ADDENDUM NO. 2

New FMDC Grounds & Maintenance Building
FMDC Maintenance Facility
Jefferson City, Missouri
PROJECT NO.: O2301-03

June 8, 2023

SUPPLEMENTAL SHEET 1.E-101
6/8/2023

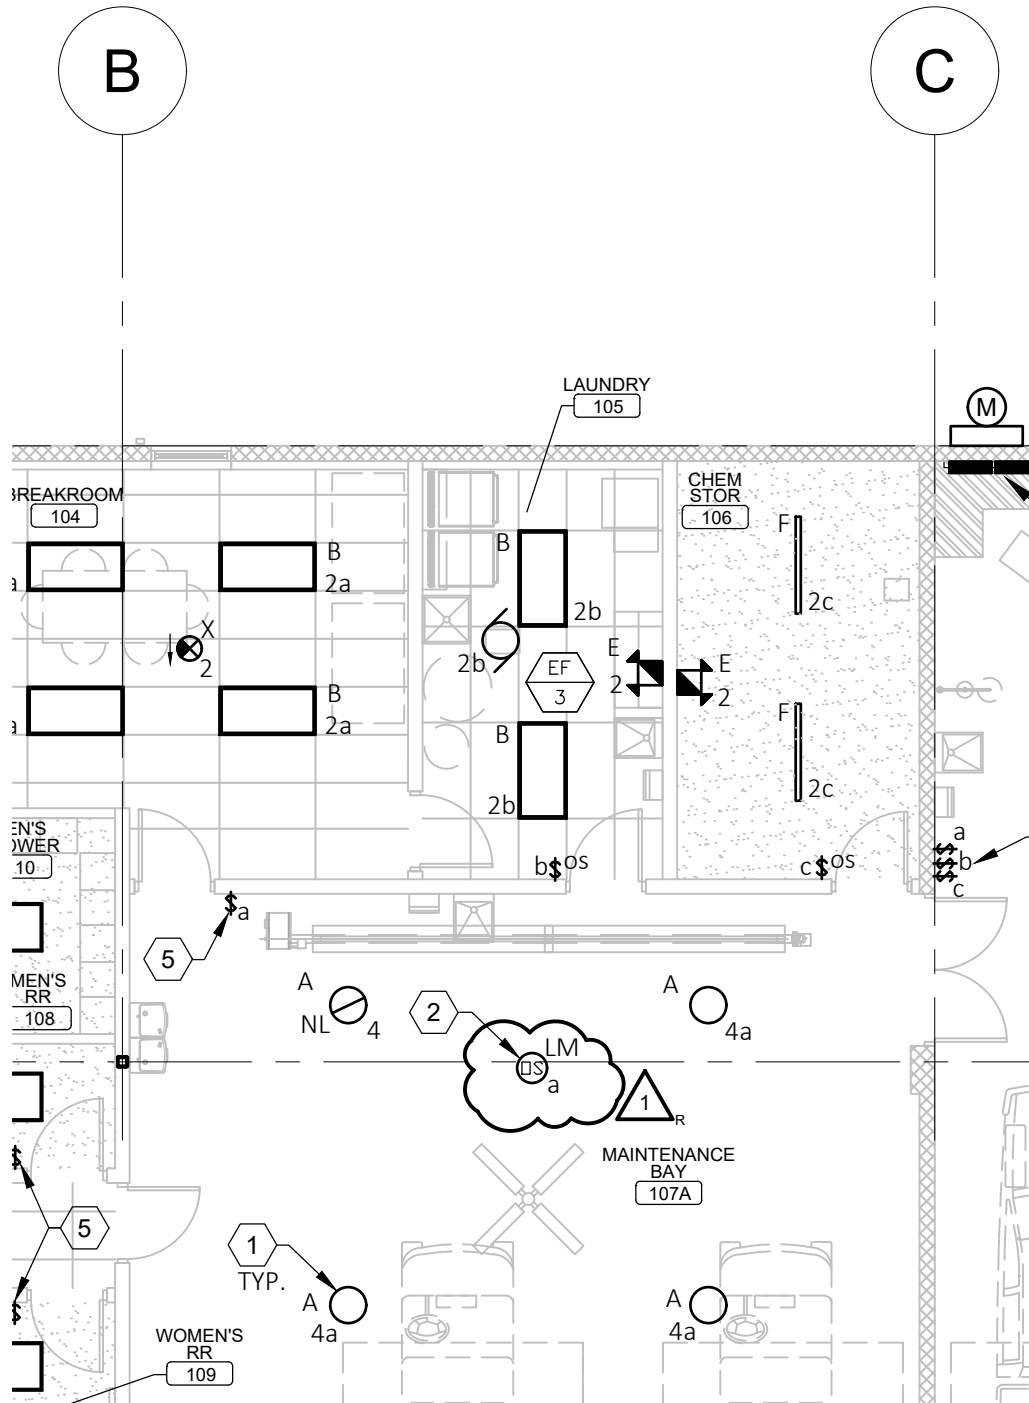
- a. At 1/E-101 ELECTRICAL LIGHTING FLOOR PLAN, **ADD** Occupancy Sensors to the plan. Refer to Supplemental Sheets 1.E-101 and 2.E-101 for type, location and quantity.

SUPPLEMENTAL SHEET 1.E-102
6/8/2023

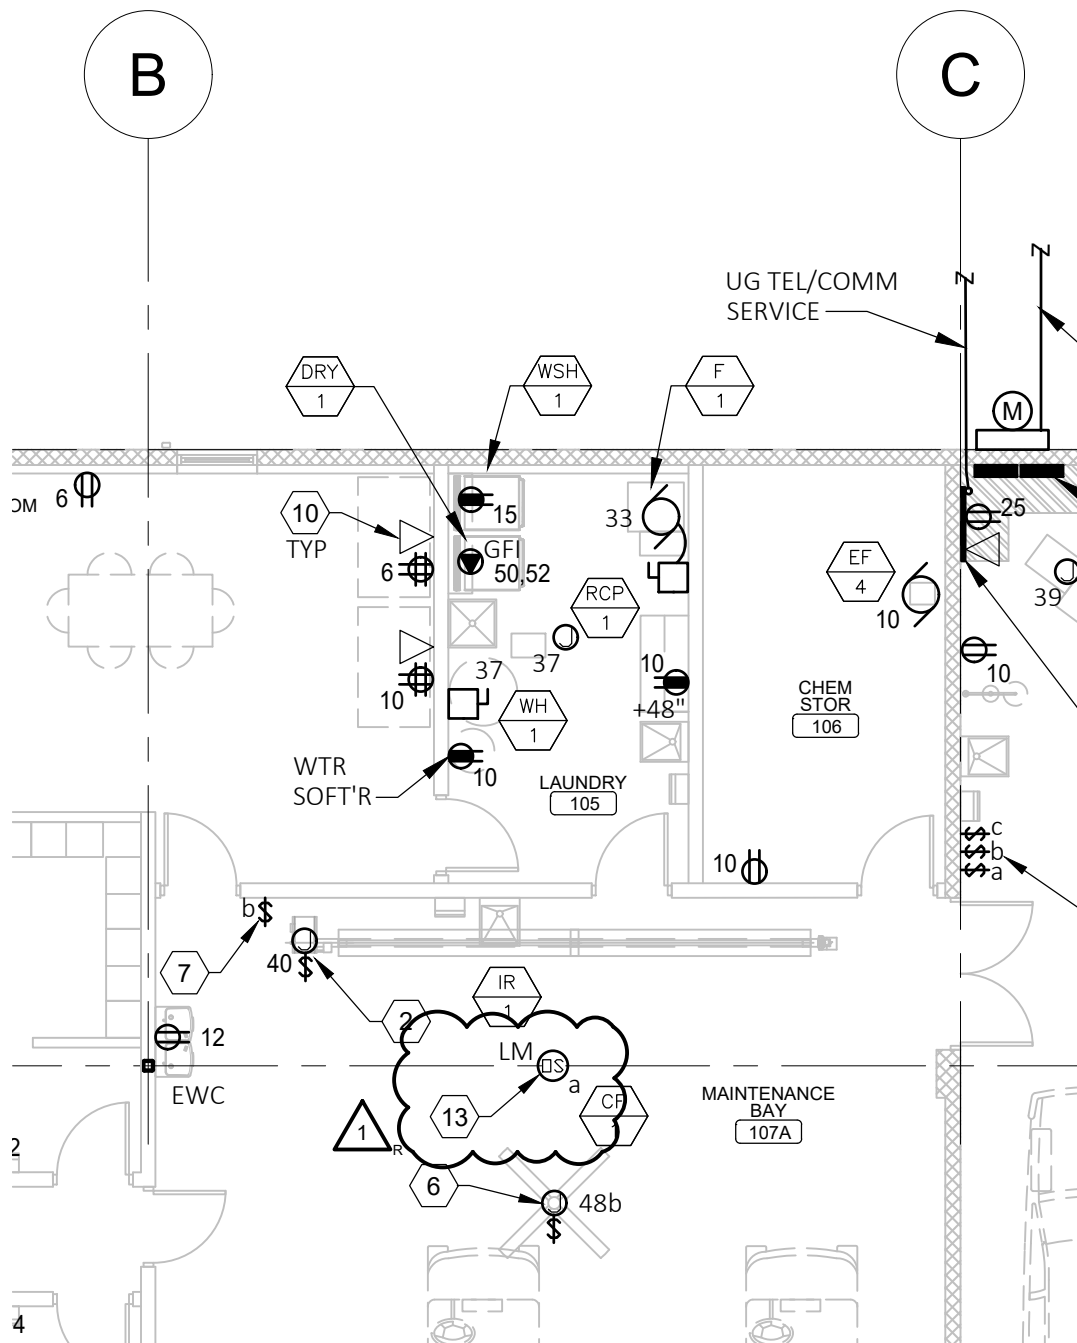
- a. At 1/E-102 ELECTRICAL POWER FLOOR PLAN, **ADD** denotation "LM" to all Occupancy Sensors added under Addendum #2 DRAWING CHANGES item 4.a. Refer to Supplemental Sheets 1.E-102 and 2.E-102 for affected Occupancy Sensors.
- b. At 1/E-102 ELECTRICAL POWER FLOOR PLAN, in MAINTENANCE BAY, #107B: – the Occupancy Sensor in between column lines D and E, along column line 2, has been **RELOCATED** to the east (right) by one overhead door opening (approximately 12'-0"). Refer to Supplemental Sheet 1.E-102.
- c. In KEYED NOTES, **ADD** Keyed Note #13 that shall read as follows:

13. UTILIZE AUXILIARY CONTACTS IN LIGHTING OCCUPANCY SENSOR TO CONNECT OAU-1 AND/OR EXHAUST FAN CONTROLS WITH OVERRIDE BY SWITCH IN SPACE. SEE SHEET E101.

2 TIMECLOCK WIRING DIAGRAM
SCALE: NOT TO SCALE

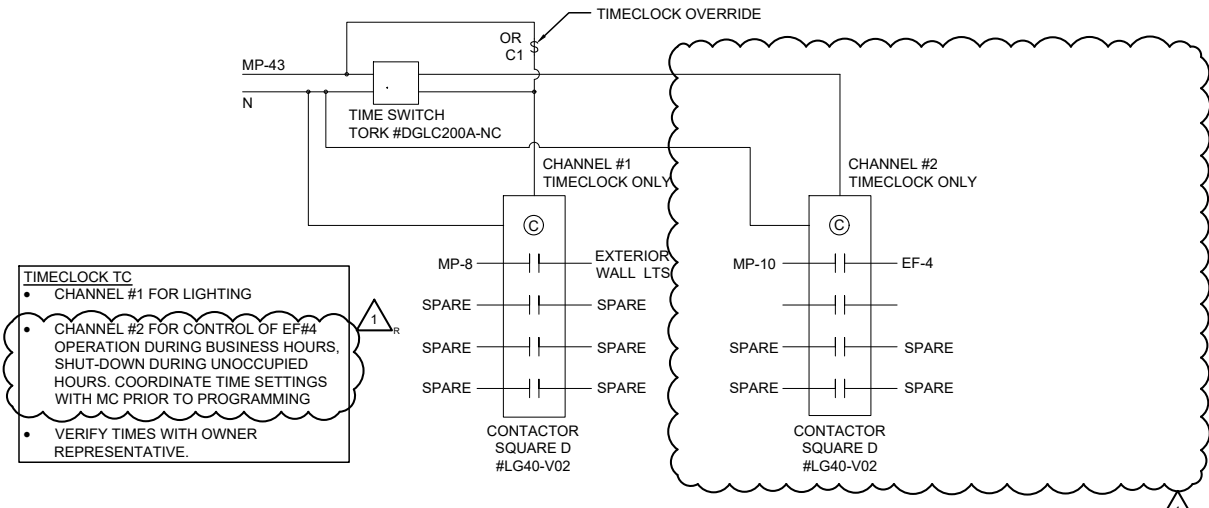
- ii. **ADD** Remark “INTEGRAL DISC SW. CONTROL BY OCC SENSOR”. *Refer to Supplemental Sheet 1.E-602.*
 - b. At 2/E-601 TIMECLOCK WIRING DIAGRAM, in Plan Note box:

- i. **REMOVE** 2nd bullet point CHANNEL #2 FOR MISC complete.
 - ii. **ADD** 2nd bullet point that reads: CHANNEL #2 FOR CONTROL OF EF #4 OPERATION DURING BUSINESS HOURS, SHUT-DOWN DURING UNOCCUPIED HOURS. COORDINATE TIME SETTINGS WITH MC PRIOR TO PROGRAMMING. *Refer to Supplemental Sheet 1.E-602.*

- iii. **REVISE** CHANNEL #2 TIMECLOCK ONLY portion of diagram. *Refer to Supplemental Sheet 1.E-602.*
 - c. At PANEL MP Panel Schedule:
 - i. **REMOVE** Description EF-4,5,6 and HVAC figure 1.8 from CKT-42.
